SUNCOKE ENERGY SOUTH SHORE FACILITY

RESPONSE TO SITING BOARD STAFF'S FIRST DATA REQUEST TO SUNCOKE ENERGY SOUTH SHORE LLC

Case #: 2014-00162

**RESPONSE TO SITING BOARD STAFF'S FIRST DATA REQUEST TO SUNCOKE
ENERGY SOUTH SHORE LLC**

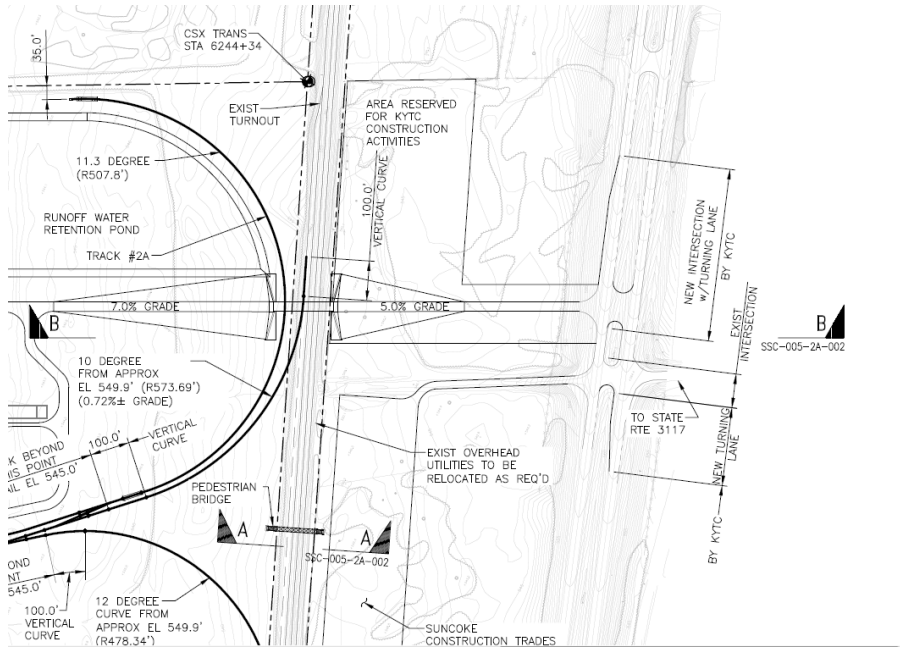
b. Provide a description of the drive off of Route 23 along the southern boundary that will provide access to the subject property.

SunCoke received information from the KYTC in preliminary discussions about an overpass, but design work has not started. Funding for the overpass has not been identified and will not be identified until such time as there is a commitment from SunCoke to build and operate the facility as proposed to the Kentucky Economic Development Cabinet. SunCoke utilized the preliminary information in its general arrangement of the plant consistent with typical guidelines of CSX and the KYTC.

Below is an image depicting the general arrangement layout utilized for the entrance access to the plant:

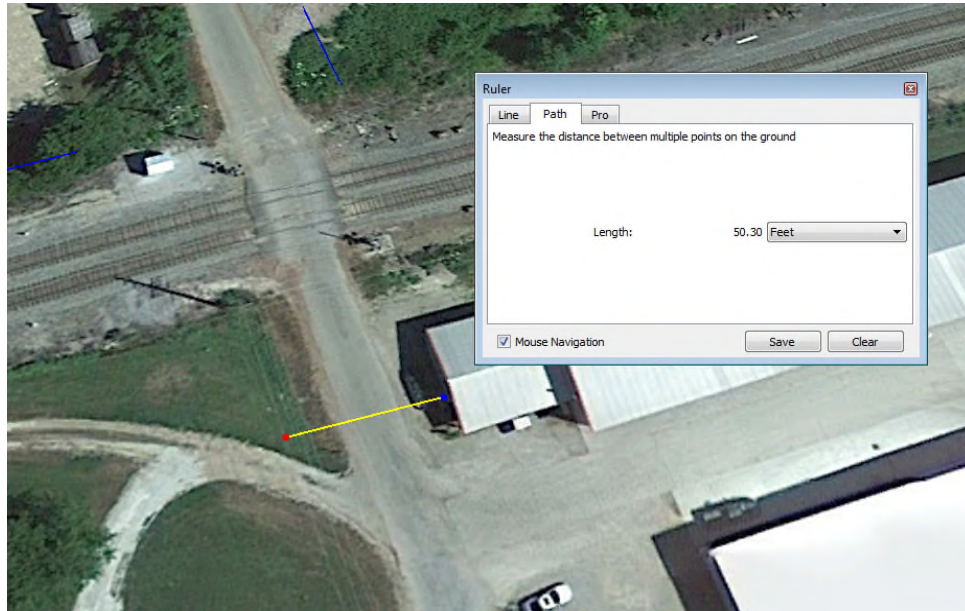
a. Was Graf Brothers concerned about the potential increased traffic on Johnson's Lane that could occur because of the bridge overpass? If so, explain in detail.

In response to Graf Brothers' concerns, SunCoke relocated the bridge overpass onto SunCoke's property. The current general layout for the bridge overpass is depicted with the yellow oval on the western (left) portion of the photo below, compared to the original design, indicated with the yellow oval on the eastern (right) portion.

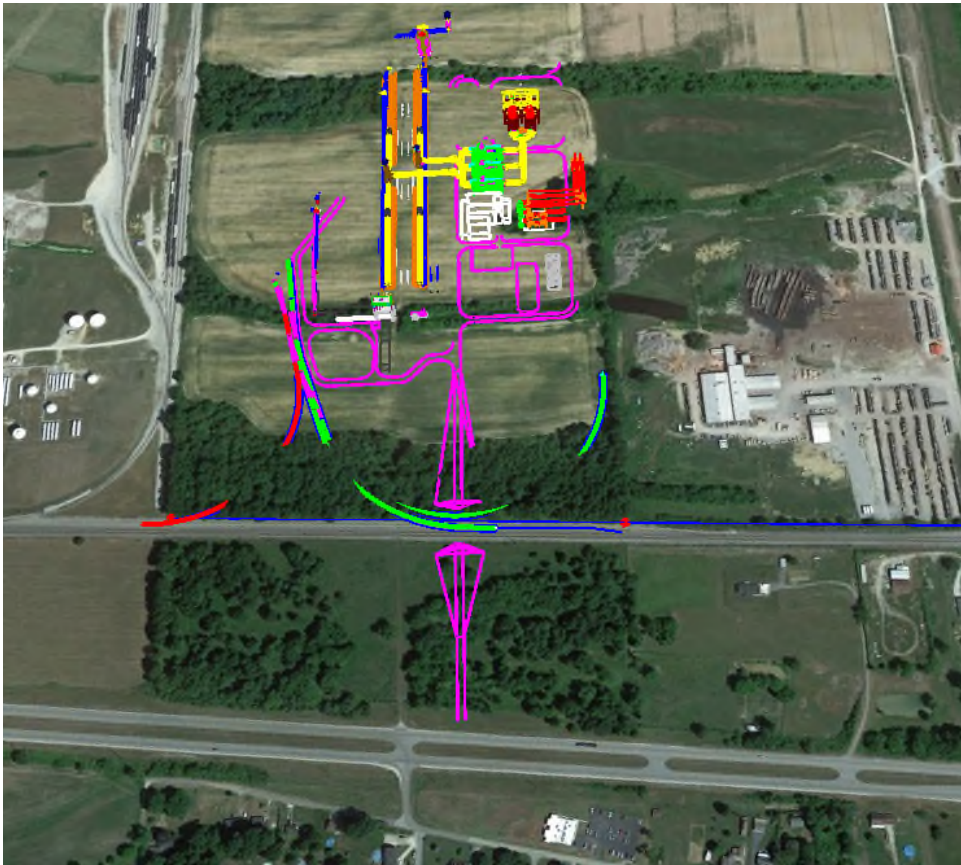
a. *Provide a description of the "negligible increase" on the noise levels the proposed facility would have on the area, particularly in reference to the Sand Hill community directly south of the proposed site.*

Middletown data indicates the highest sound pressure level within the plant (excluding sound level within the steam turbine generator building) during operation was roughly 80 dBA. Typical sound pressure levels in the balance of the plant were on the order of 65 dBA. During the same period sound levels on the adjacent road way <1,500 feet from operations indicated

The figure below illustrates the relative locations and anticipated sound levels based on the reference table and the Middletown plant noise data.

The closest residents of the Sand Hill neighborhood are roughly 220 feet from U.S. Highway 23 (per the above reference table freeway noise at a distance of 50 feet is roughly 76 dBA), 1,020 feet from the CSX rail main line (per the above reference table freight trains produce 80 dBA at 15 meters), almost 2,000 feet from the nearest operating unit (Quench tower which based on the Middletown data posted sound levels of roughly 66 dBA), and over 2,800 feet from the highest sound level in the plant (excluding sound levels inside the steam turbine generator building) of 80 dBA representing the area surrounding the air quality control system.

- 3.) The closest plant operating unit is the quench tower operation (within 1,950 feet of the closest residence) with an expected level of 66 dBA based on Middletown data. The expected sound pressure level at the closest residence from this source calculates to roughly 28 dBA.

- 4.) The highest noise contributor in the plant from Middletown data is the air quality control system which also happens to be the furthest unit away (over 2,800 feet from the closest residence) and recorded levels of 75 to 80 dBA. The expected sound pressure level at the house from this source calculates to roughly 39 dBA.

- 6.) Finally, utilizing contributions from just the Highway and the Rail prior to the plant would generate a sound pressure level of 63.5 dBA at the closest residence (close in relation to the 60 dB background level measured by MEA). Adding contributions from 3, 4, and 5 with the addition of the plant would generate an expected sound pressure level at the closest residence of 63.9 dBA. Literature suggests a 3 dBA shift is required for the human ear to

discern a change. Therefore, this change in noise level is not discernible to the human ear and thus we state this as “negligible”.
